Appl. No. 10/773,727
Response to Office Action Mailed March 23, 2005

Title: Method and Structure of Manufacturing High Capacitance Metal on Insulator Capacitors in Copper
Applicant: Xian Jie Ning
Annotated Drawing Sheet 1 of 3

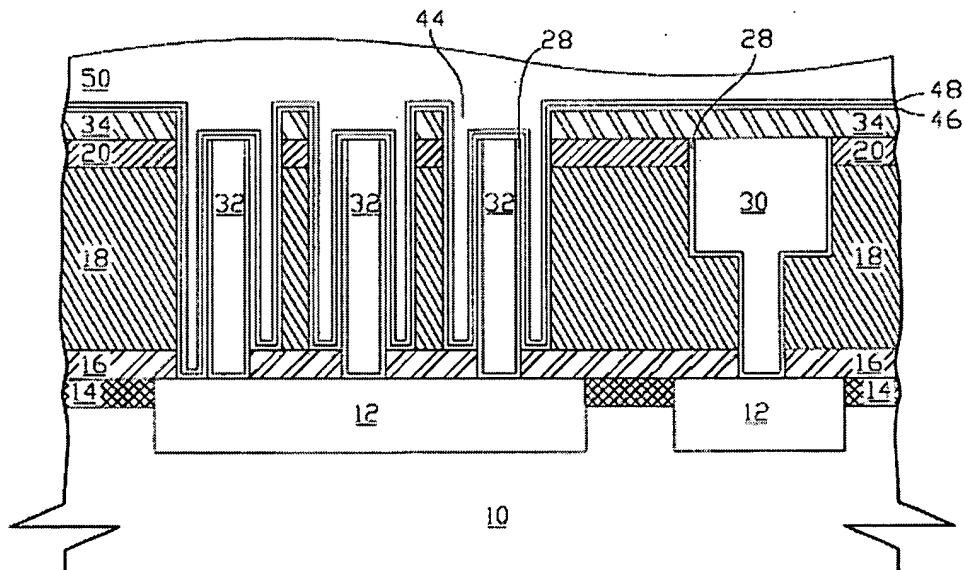
Here, the Tsai Patent fails to teach fabrication of a capacitor structure from a metal array structure. Figure 7 of the Tsai Patent is reproduced below:

As shown in this Figure 7, the capacitor of the Tsai Patent is not formed from an array of metal structures. Rather, metal (50) is formed within an inverse U-type opening (44), defined by the stack comprising first dielectric material (18), first hard mask layer (20), and cap layer (34). None of the components of this stack of material are metals, and thus the Tsai Patent cannot be understood to teach or even suggest formation of a capacitor structure from a metal array.

Fig. 1. To form a damascene structure build in IMD and metal barrier is deposited. An array of VIAs are built for MIMCap.

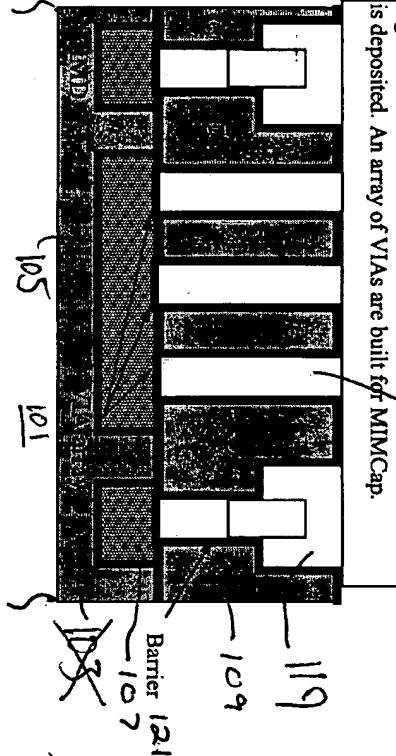
In the latest office action, the Examiner objected to various portions of the specification and drawings. Accordingly, the specification and drawings have now been amended to remove these objections. Specifically, Figure 1 and the specification have now been amended to delete reference no. "103". Figure 1 has also been amended to correct reference no. "117" to "111", and to add reference nos. "107", "109", and "121" in the appropriate places. Figure 2 and the specification have been amended to delete reference no. "203". Figure 6 has been amended to change the position of reference no. "601", and to add reference no. "603". Applicant has filed replacement sheets for the above-referenced amended Figures. Other portions of the specification have been amended in the manner requested by the Examiner, or to correct errors of typographical nature. No new matter has been added to the application by virtue of these amendments.

The attached sheets of drawing includes changes to Figures 1-2 and 6. These sheets, which includes Figures 1-2 and 6, replace the original sheets including Figures 1-2 and 6.

Annotated Drawing Sheet 3 of 3

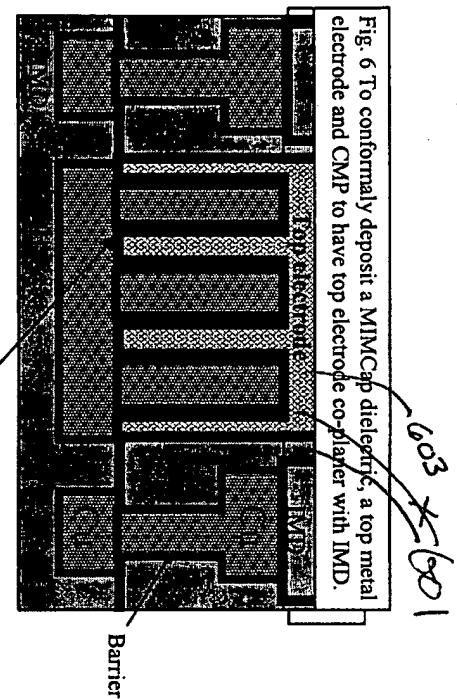
As shown in Figure 6 of the instant application, fabrication of the capacitor structure is completed by forming metal within the opening between the arrayed metal structures.
